AP1000 DOCUMENT NO. APP-GW-GLR-134	REVISION 4	PAGE 1 of 566	ASSIGNED TO W-Sisk	OPEN ITEMS (Y/N)
---------------------------------------	---------------	------------------	-----------------------	------------------

**TITLE: AP1000 DCD Impacts to Support COLA Standardization**

# **AP1000 Standard Combined License Technical Report**

## **AP1000 DCD Impacts to Support COLA Standardization**

Figure 3H.5-9 (Sheet 1 of 3)

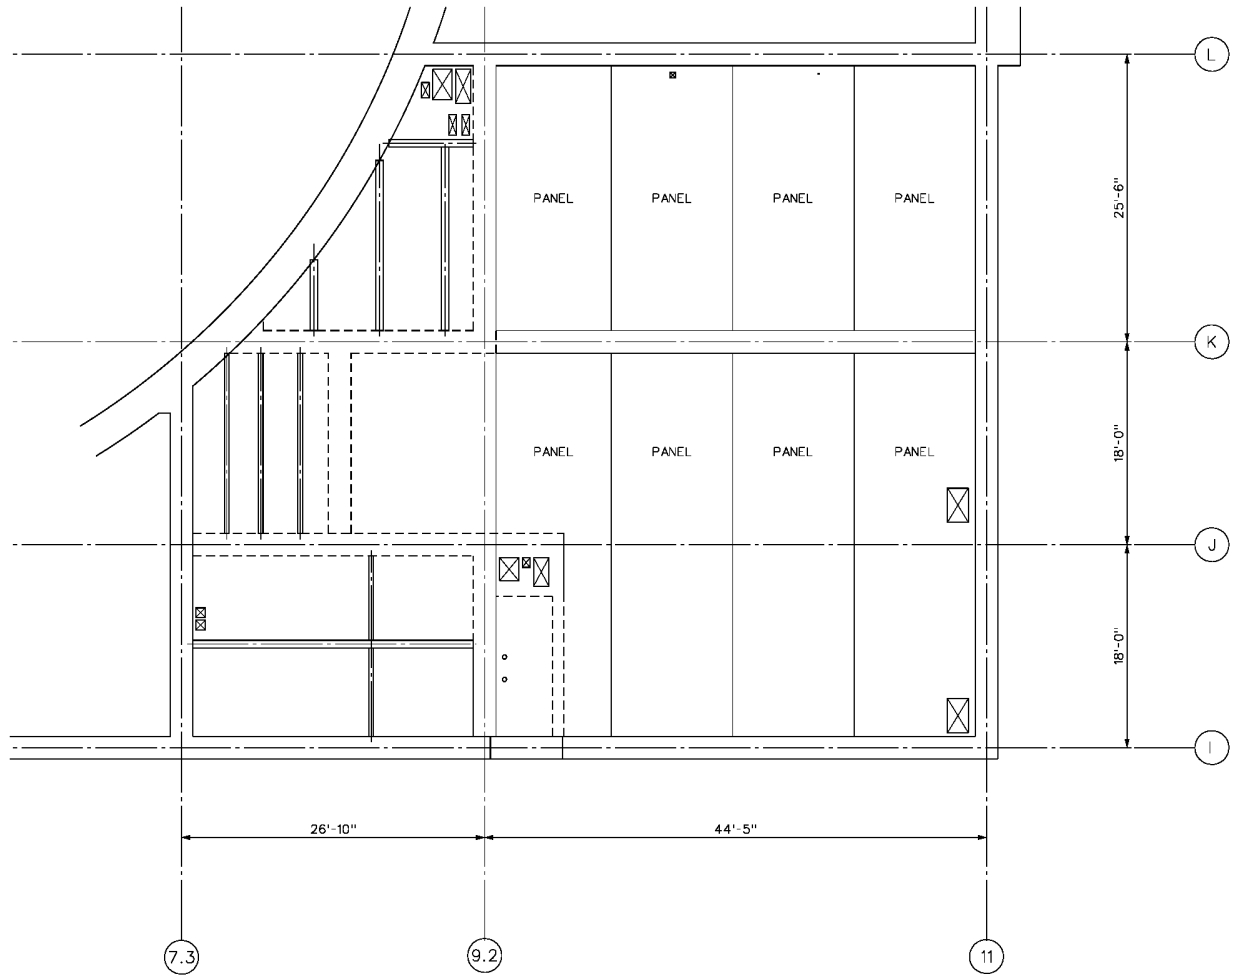
**NRC 094 contains corrections to Figure 3H.5-9 sheet 1 and Figure 3H.5-12 of the DCD Revision 16 to be consistent with TR 57, APP-GW-GLR-045, Rev 0.**

Figure 1.2-1

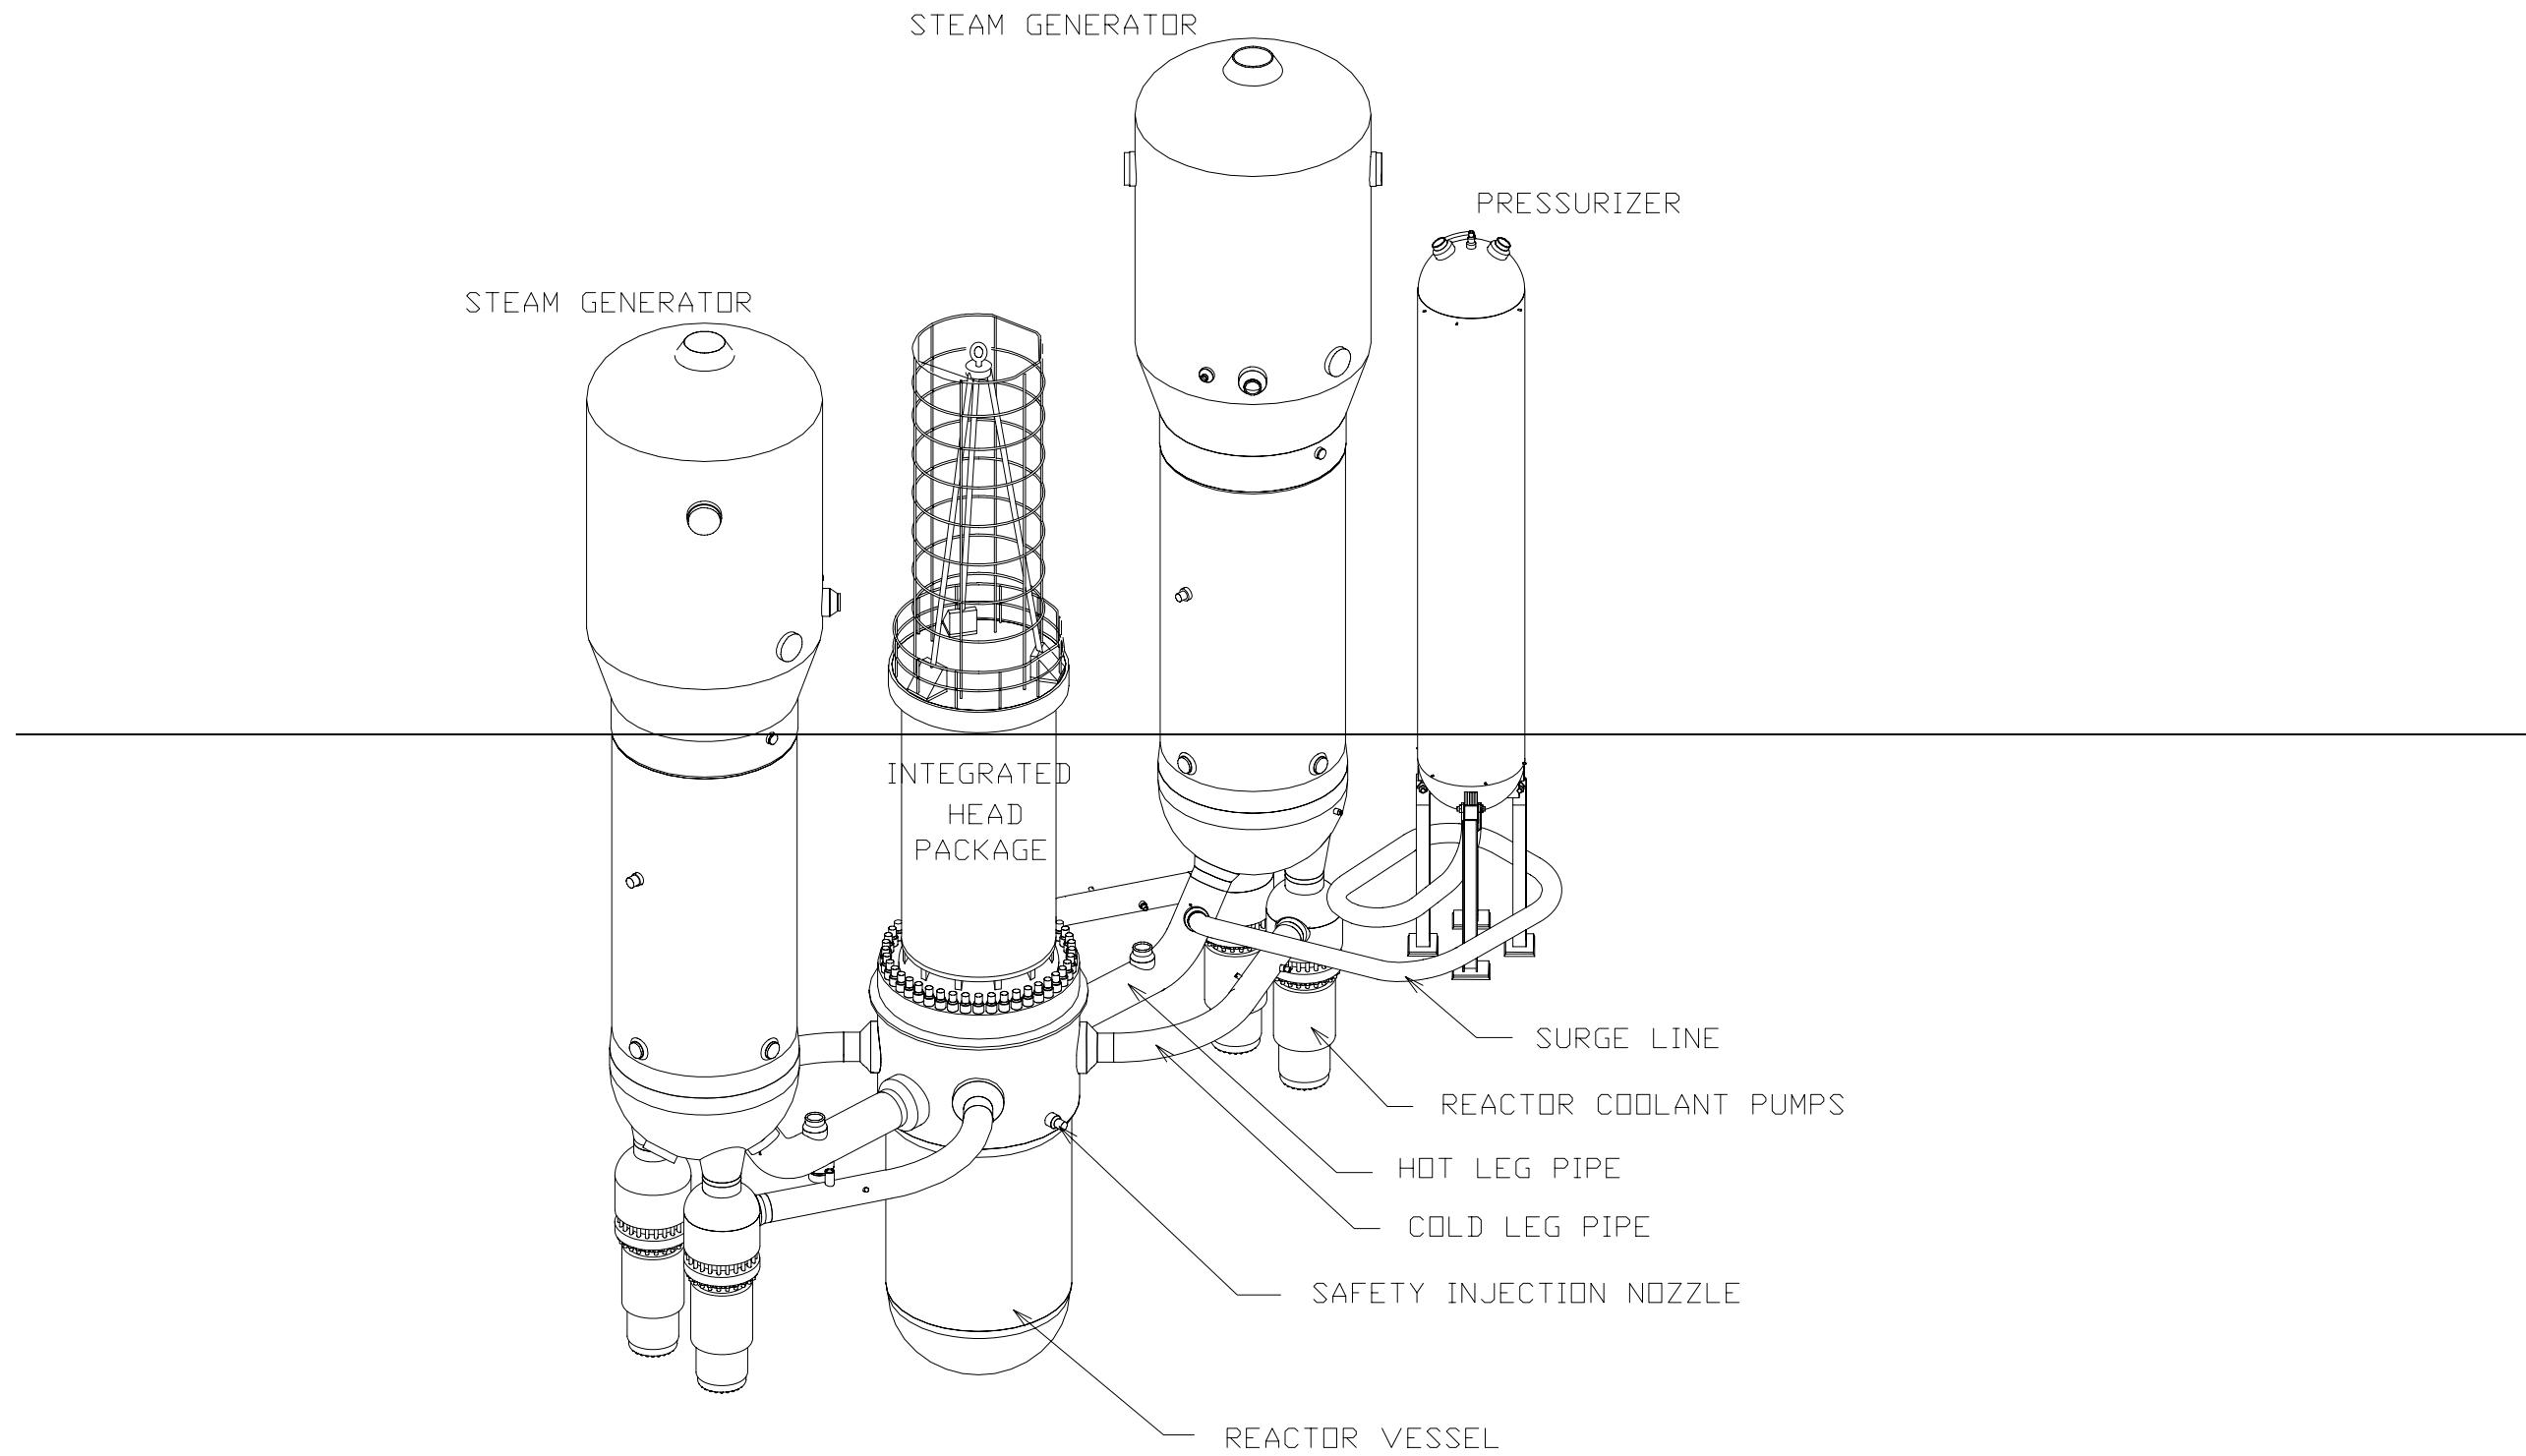
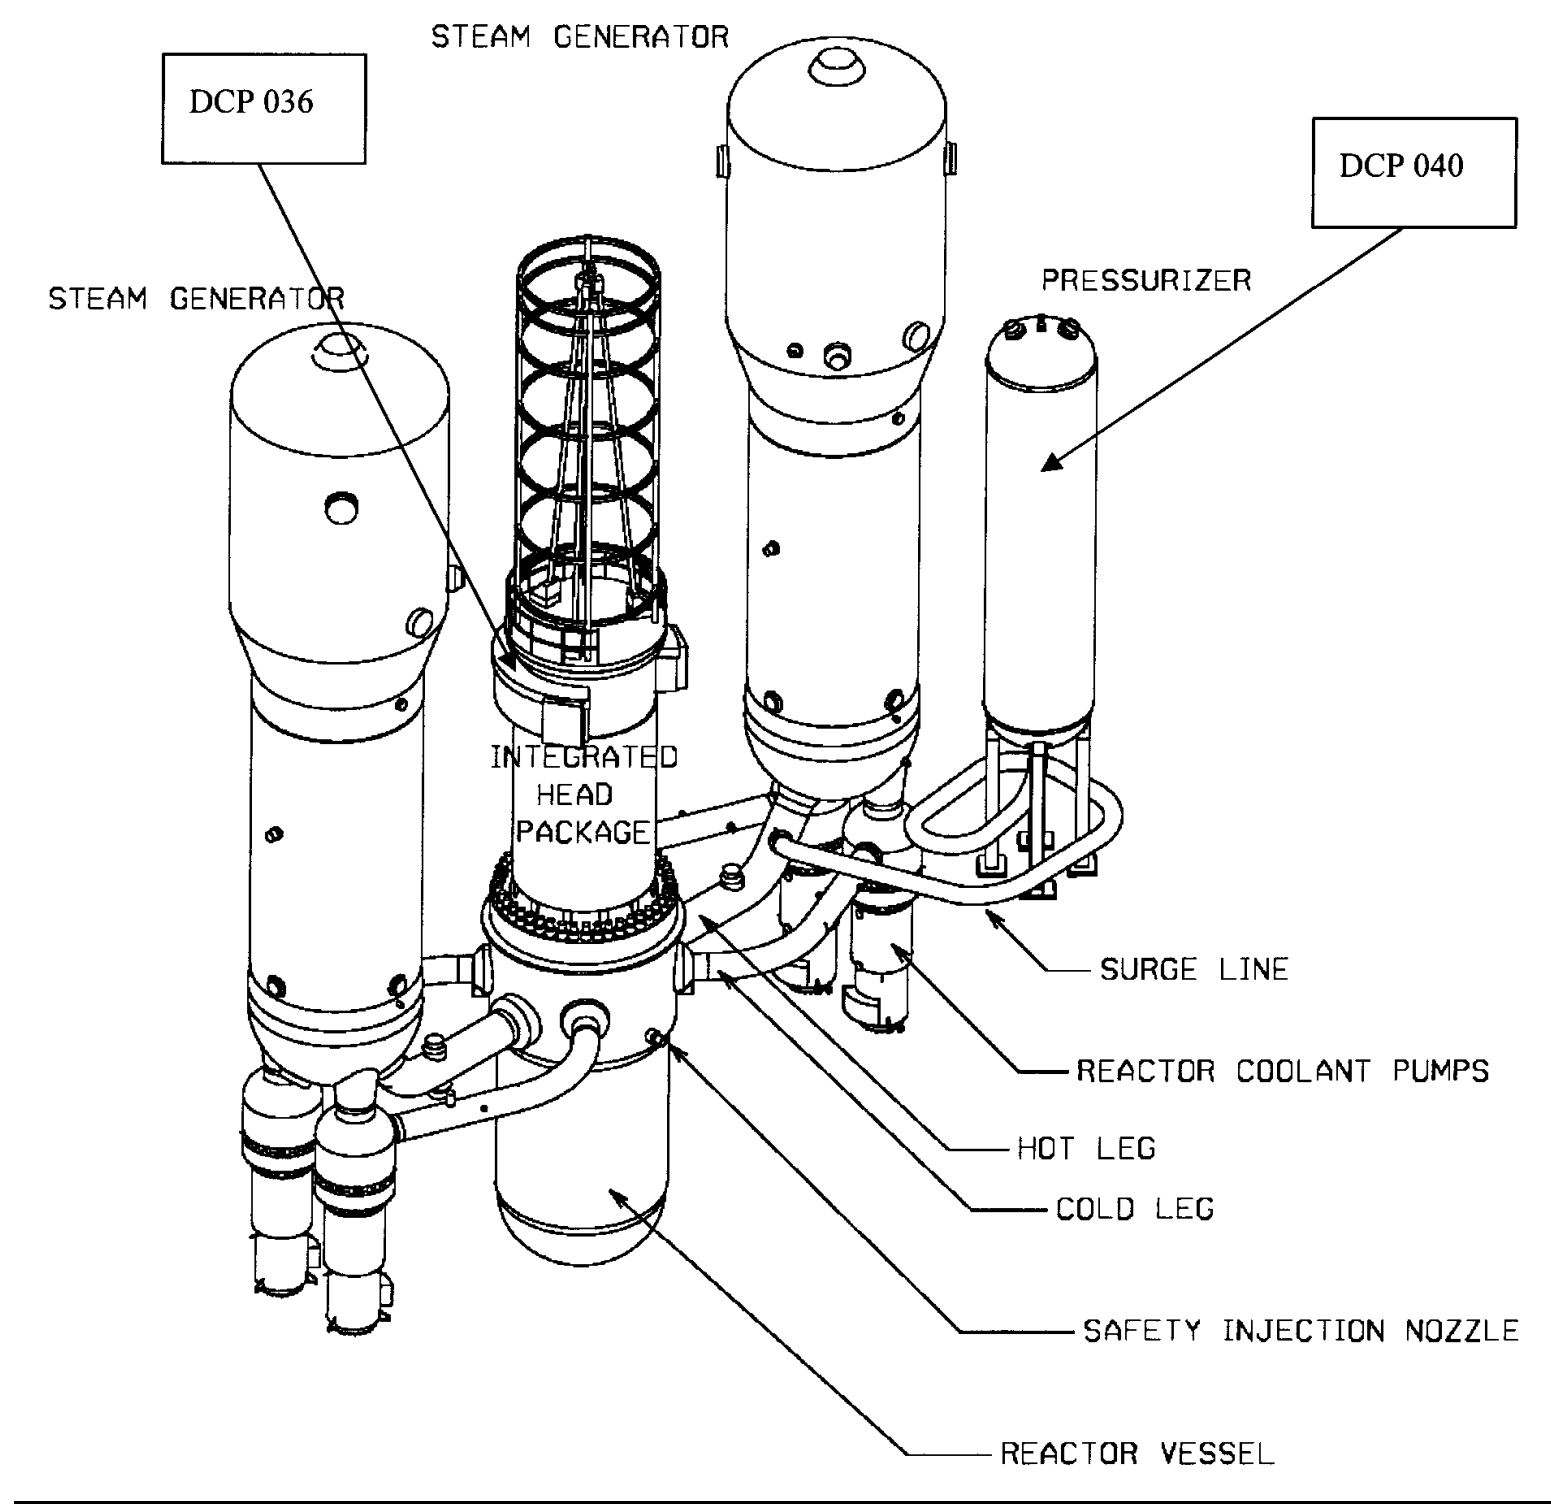
NRC106 contains corrections to Figure 1.2-1, 5.1-2 and Figure 1.2-9. The basis for the change is TR36 APP-GW-GLR-016.

Figure 3.8.2-4 (Sheet 2 of 6)

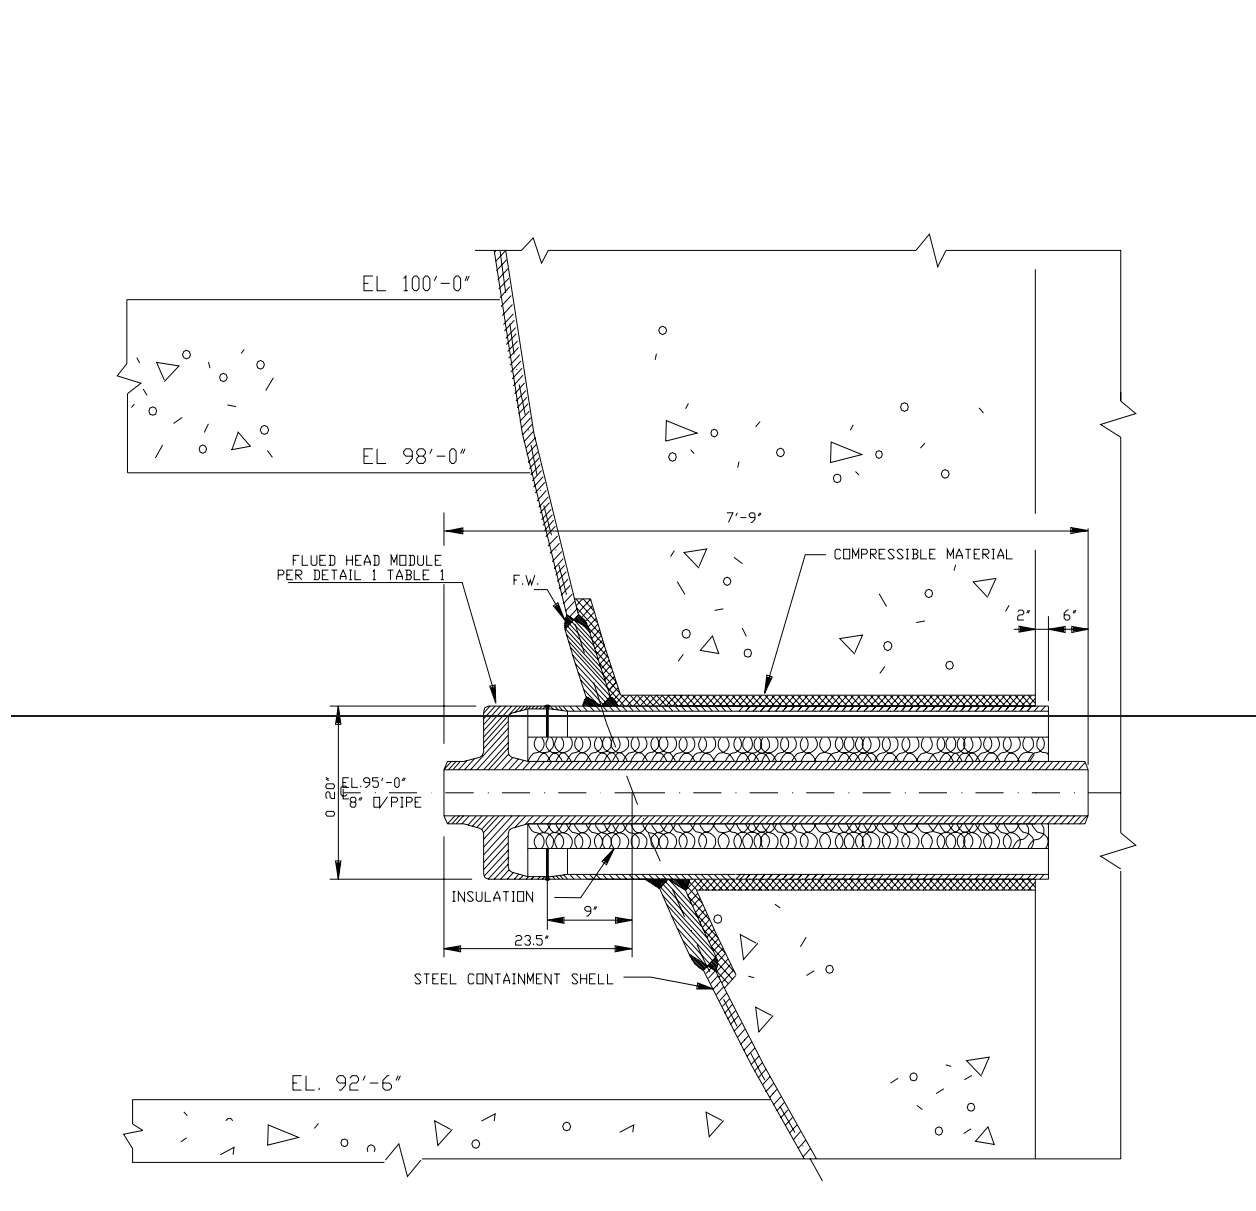
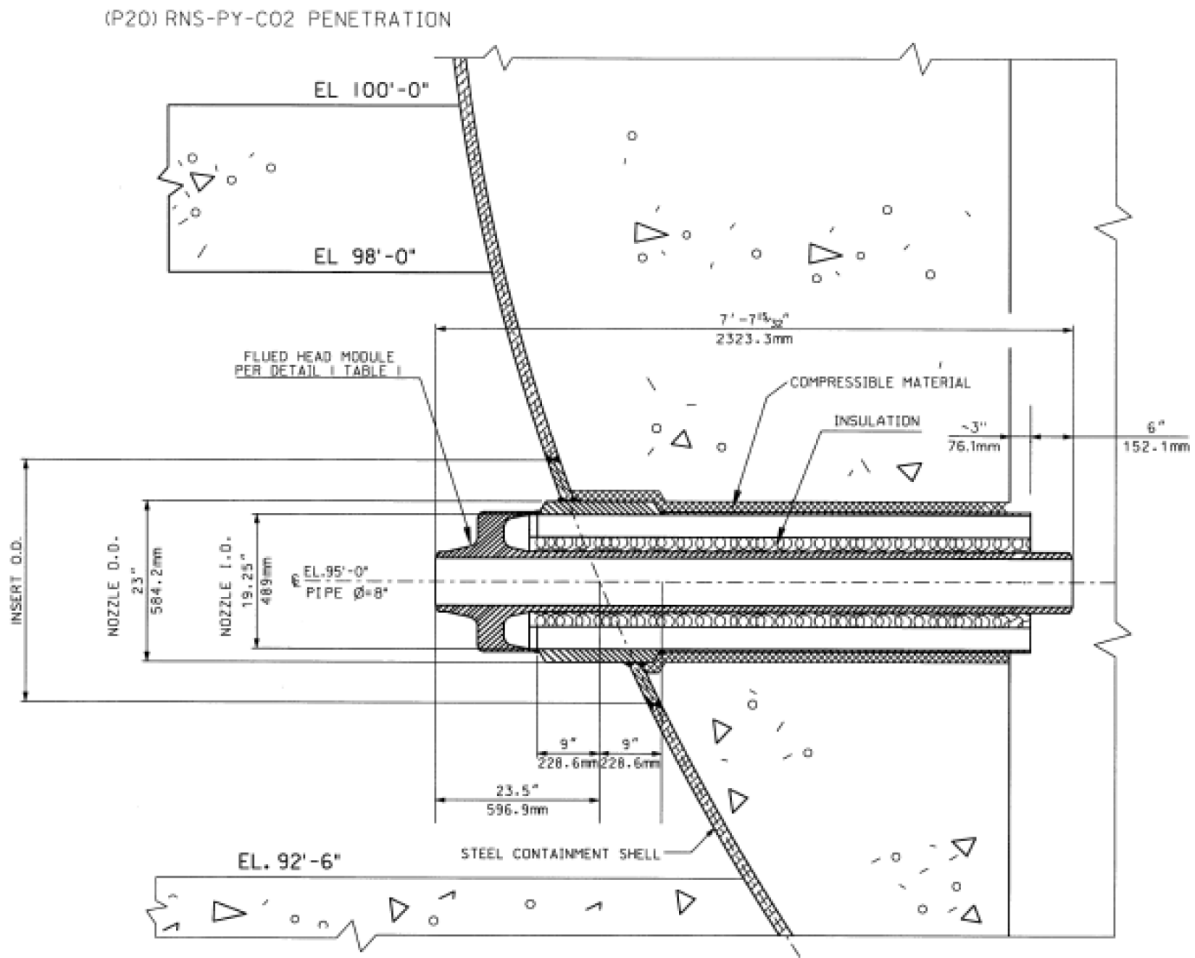
**NRC044 contains corrections to Table 3.2-3, Figure 3.8.2-4 of DCD Revision 16. The basis for the change is RAI-TR09-003.**
